SUPPLEMENT
16 JULY 1954

SUPPLEMENT TO
TM 11-851
RADIO SET SCR-244-D
AND
RADIO RECEIVERS
R-274A/FRR,
R-274C/FRR,
R-320A/FRC,
R-483/FRR,
AND
R-483A/FRR

The following information, published on Order No. 25693-Phila-53 supplements TM 11-851, October 1953. The equipment covered in this supplement is:

Figure 14.1. Radio Receiver R-620/FRR, tube location.

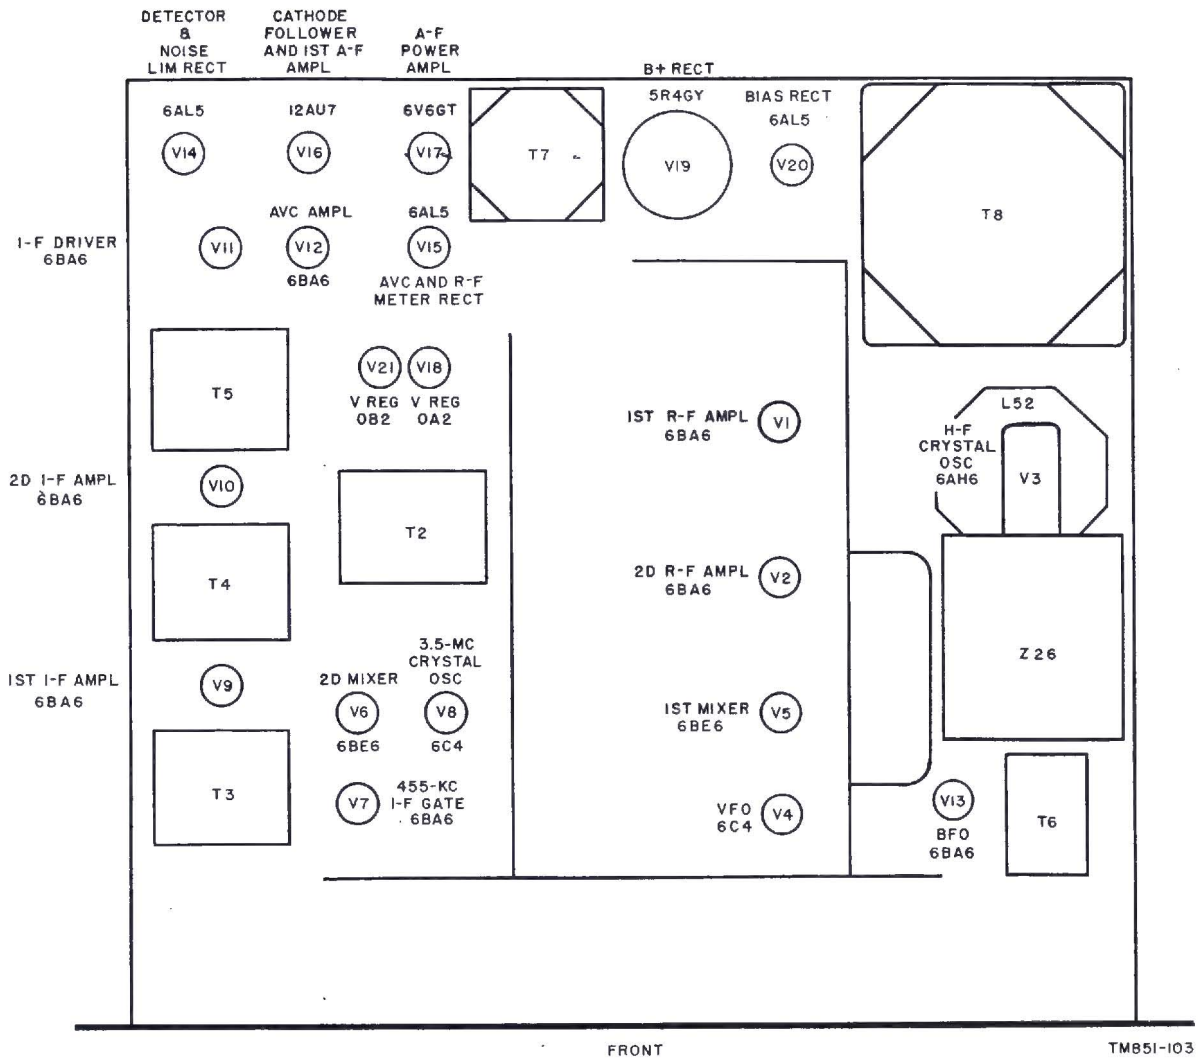
Page 28. Par. 24b. Line 4. Change "(fig. 13 and 14)" to read: (fig. 13, 14, and 14.1).

Page 30. Fig. 14. Insert figure 14.1 after figure 14.

Figure 22.1. Radio Receiver R-620/FRR, block diagram.

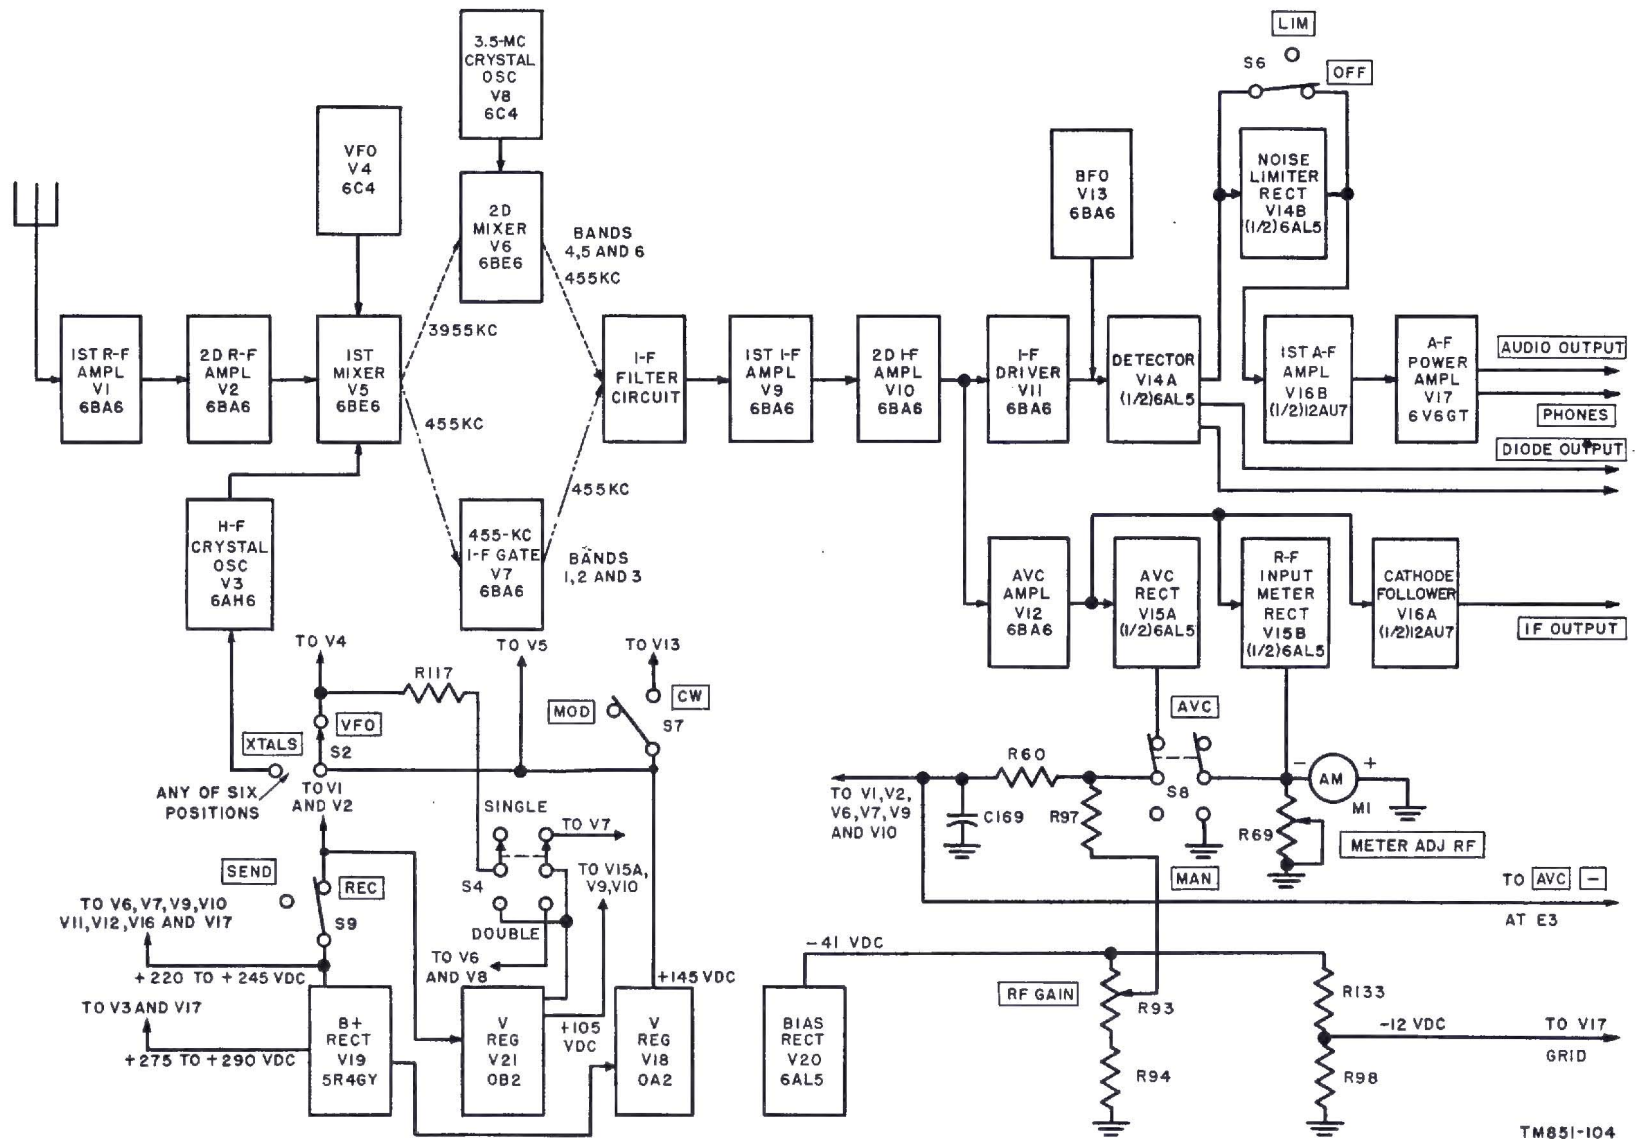
- Page 54. Fig. 22. Caption.** Change "receivers"
to read: receiver.
- Page 54. Fig. 22.** Insert figure 22.1 after figure
22.
Change "(figs. 99 through 102)" to (fig.
97 through 102.1) in the following places
in the manual.

- Page 55. Par. 53n. Heading.** Add: (fig. 22).
- Page 55. Par. 53n.** Insert the following after paragraph 53n.
n.l. Avc Amplifier (fig. 22.1). Avc amplifier V12 amplifies the 455-kc if. input fed to it from second if. amplifier V10. This stage provides input to avc rectifier V15A and V15B to cathode follower V16A.

- Page 56. Par. 53q. Line 1.** After "V14B", add: (fig. 22).
- Page 56. Par. 53q. Line 3.** To sentence ending in "V11", add: (fig. 22).
- Page 56. Par. 53q.** Add the following to the paragraph: In figure 22.1, avc rectifier V15A derives input from avc amplifier V12. The avc bias voltage developed by V15A is applied to the grids of V1, V2, V6, V7, V9, and V10.

- Page 56. Par. 53r. Line 2.** After "V15A", add: (fig. 22), and V14B (fig. 22.1).
- Page 56. Par. 53r.** Add the following to the paragraph: V14B (fig. 22.1) derives positive bias from V14A, so that it conducts until the noise voltage causes it to be cut off, to provide for its noise limiter function.

Figure 26. Radio receiver, all types, schematic diagram of variable-frequency oscillator.

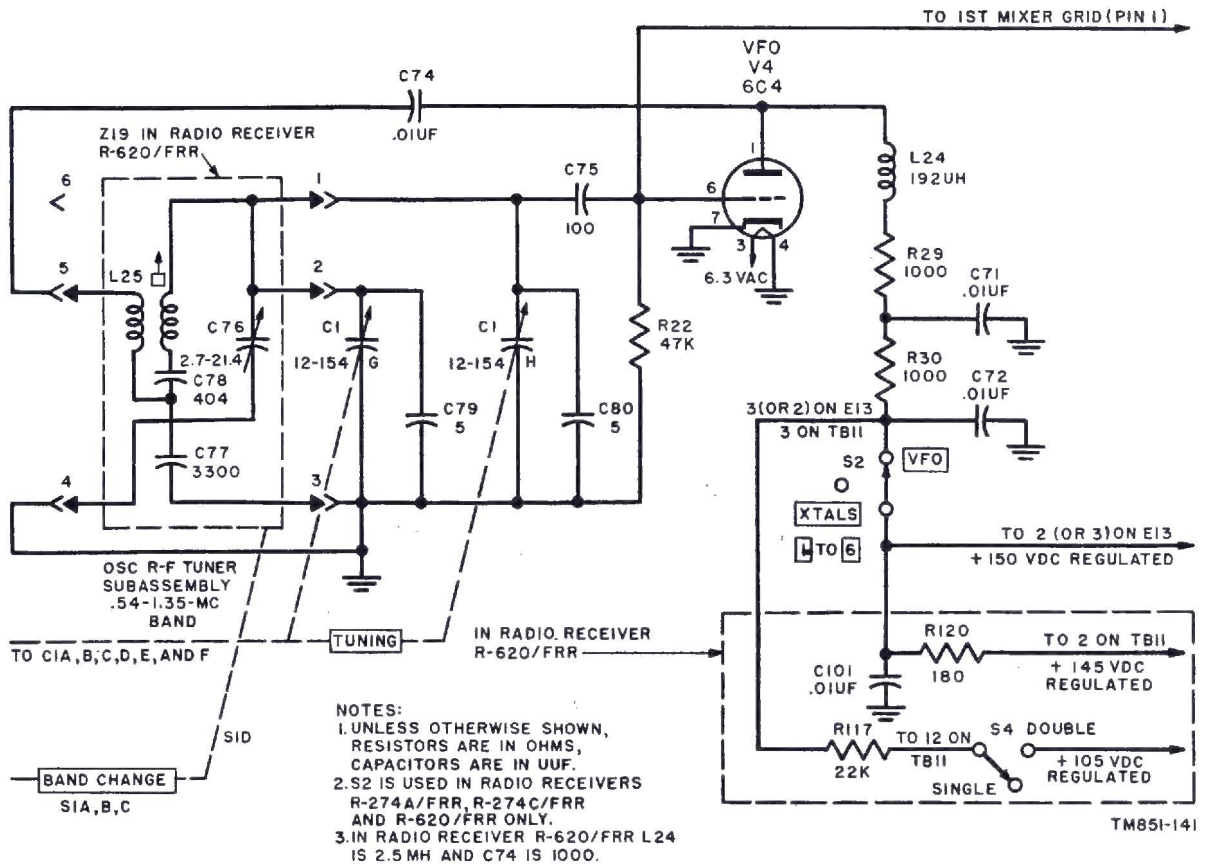
Page 62. Fig. 26. Delete figure 26 and substitute the new figure 26.

Figure 27.1. Radio Receiver R-620/FRR, schematic diagram of hf crystal oscillator shown for band 2 (1.35 to 3.45 mc).

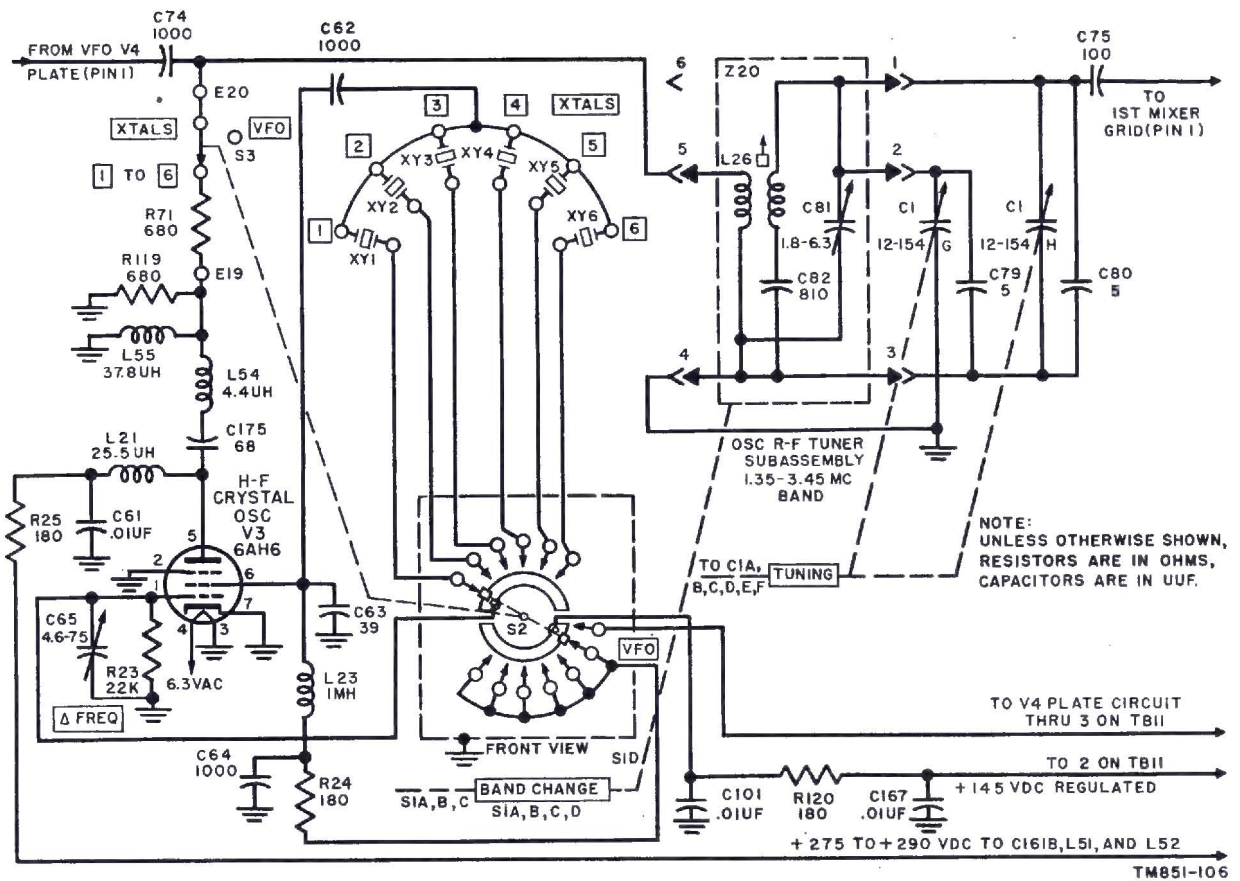
Page 63. Fig. 27. Insert figure 27.1 after figure 27.

Page 64. Par. 57c. Line 28. After sentence ending with "range." add: In figure 27.1, bandpass filter network (C175, rf coils L54 and L55, and R119) does likewise, the oscillator output being fed to first mixer V5 through R71.

Figure 31.1. Radio Receiver R-620/FRR, schematic diagram of the 455-kc if. gate.

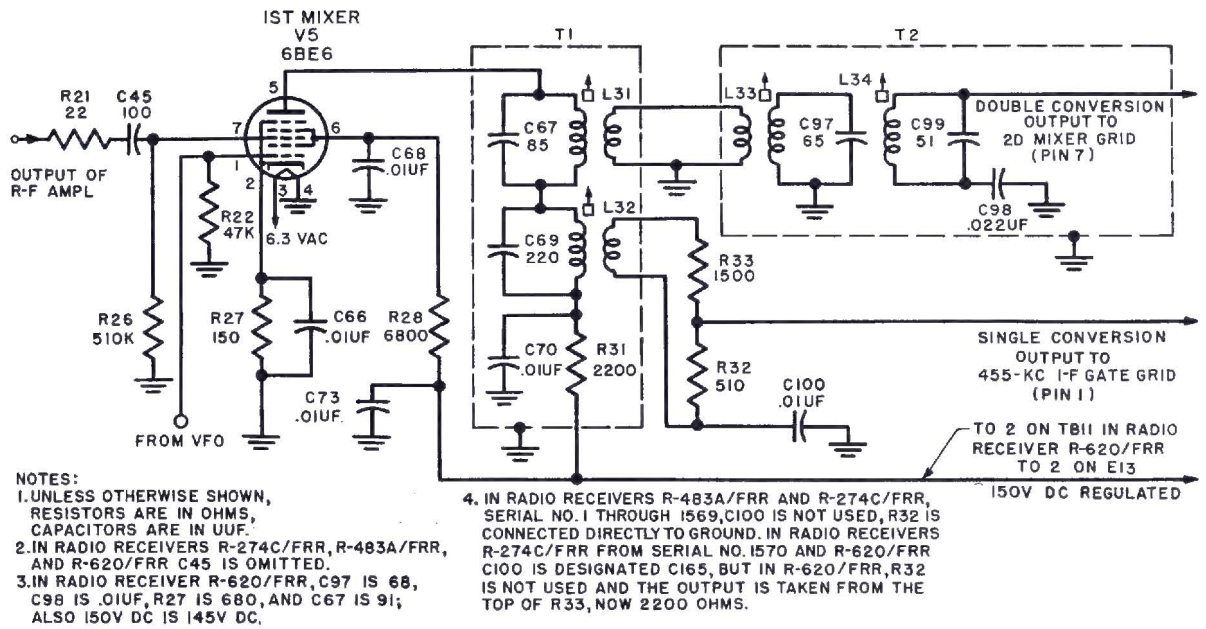
Page 66. Par. 59b. Line 7. After sentence ending with "C105)." add: In figure 31.1, screen voltage is applied through the single conversion position of switch S4 and screen grid resistor R39. R128 is the current limiter resistor for voltage regulator tube V21.

Page 67. Fig. 31. Insert figure 31.1 after figure 31.

Page 68. Par. 59c. Add the following to the paragraph: In figure 31.1, R131 is across the parallel resonant circuit (L36 and C107) so that the 8- and 13-kc frequency response curves to the 455-kc signal are relatively flat.

Figure 28. Radio receiver, all types, schematic diagram of first mixer stage.

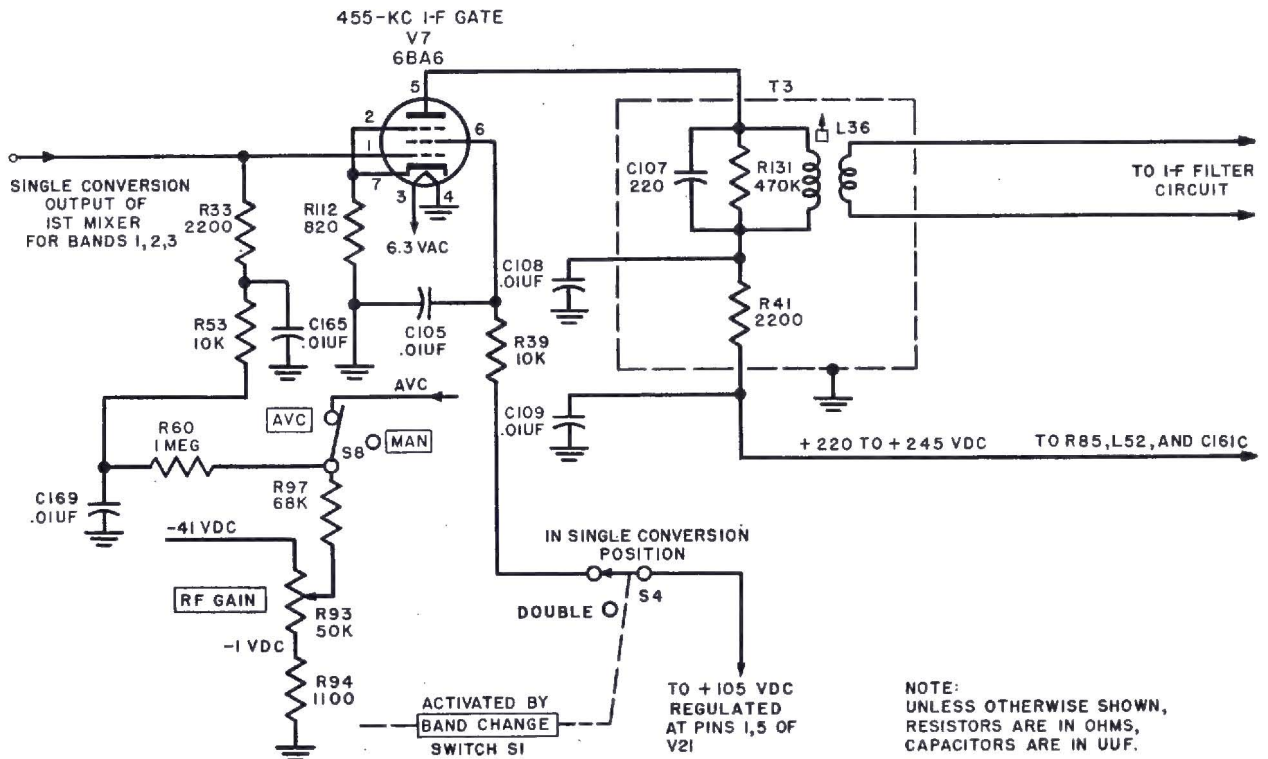
Page 65. Fig. 28. Delete figure 28 and substitute the new figure 28.

Figure 32.1. Radio Receiver R-620/FRR, schematic diagram of 3.5-mc crystal oscillator.

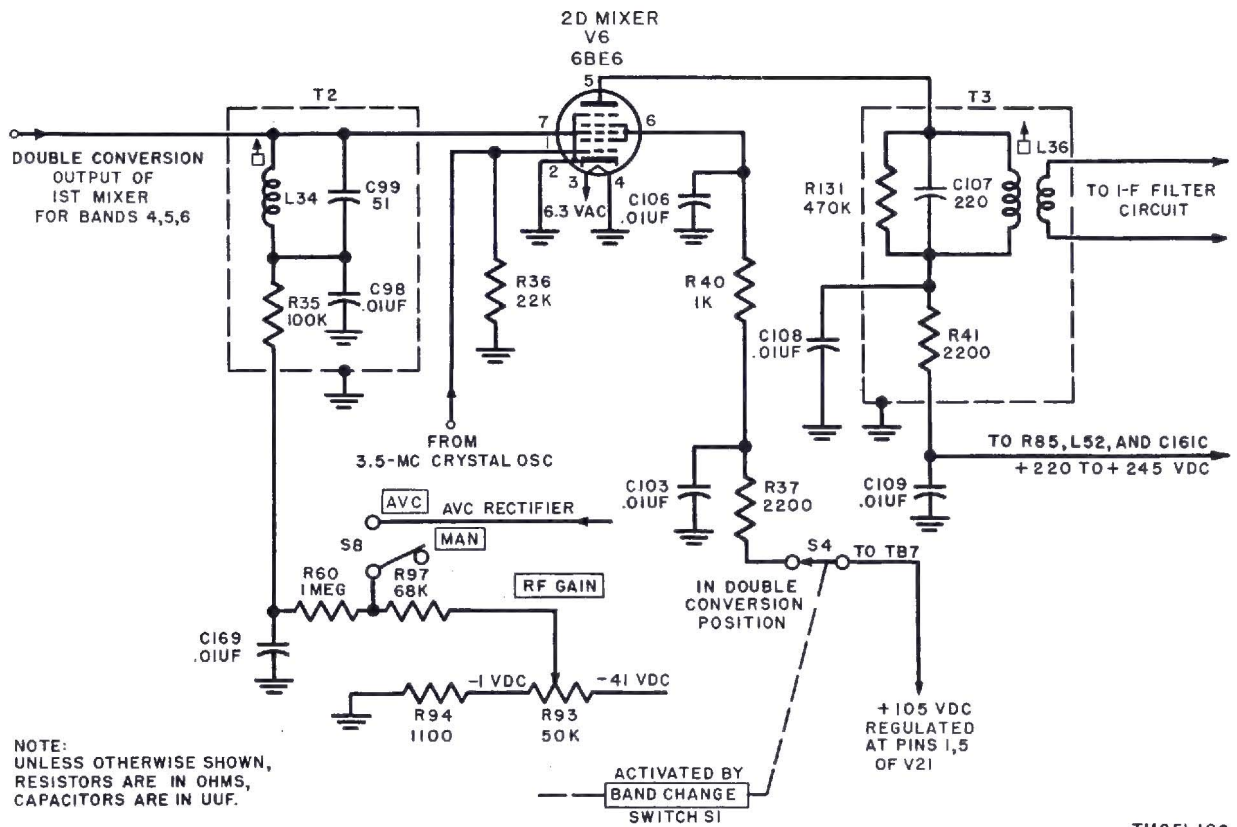
Page 68. Fig. 32. Insert figure 32.1 after figure 32.

Page 68. Par. 60b. Line 7. After sentence ending with "L35." add: (In figure 32.1, plate voltage is applied to V8 from V21 through S4 (on bands 4, 5, and 6), R37, R38, and R118.)

Page 68. Par. 60b. Add the following to the paragraph: In figure 32.1, capacitor C171 is the grid-leak capacitor.

Figure 34. Radio receiver, all types, schematic diagram of if. filter circuit.

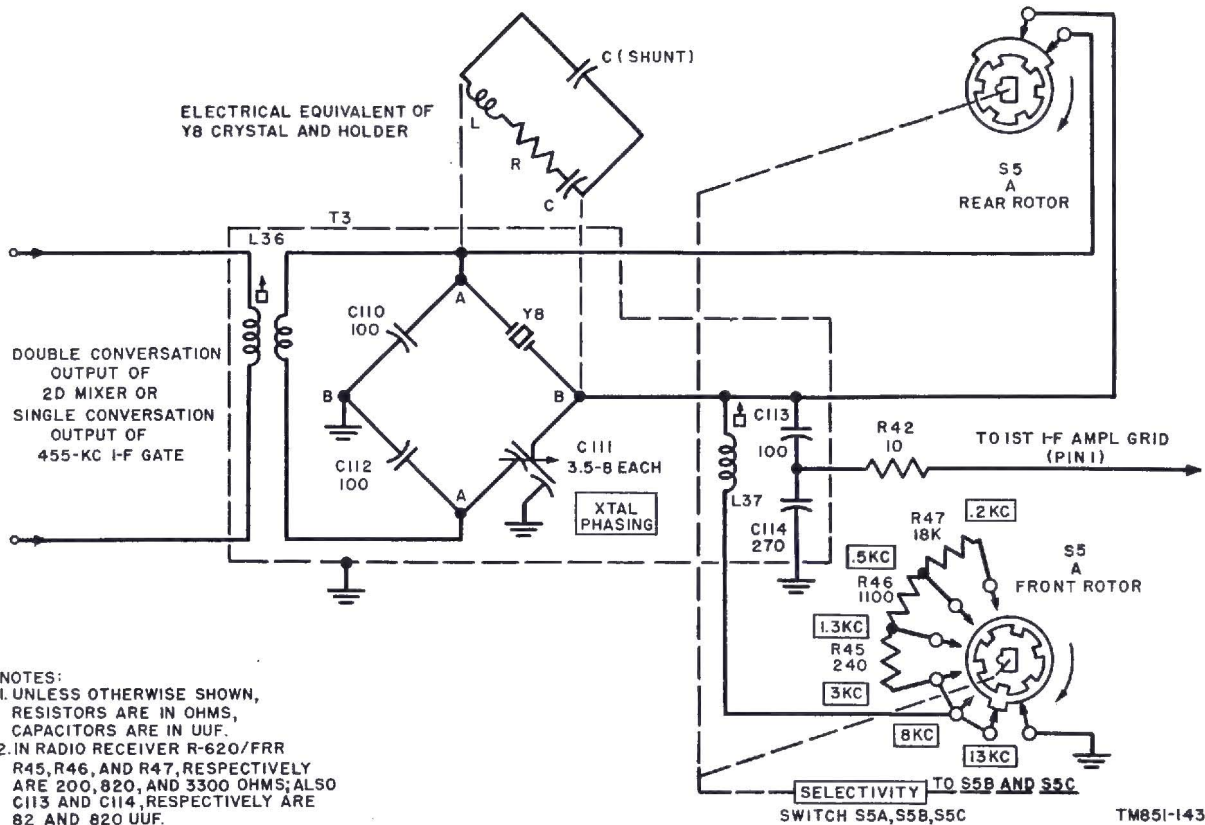
Page 71. Fig. 34. Delete figure 34 and substitute new figure 34.
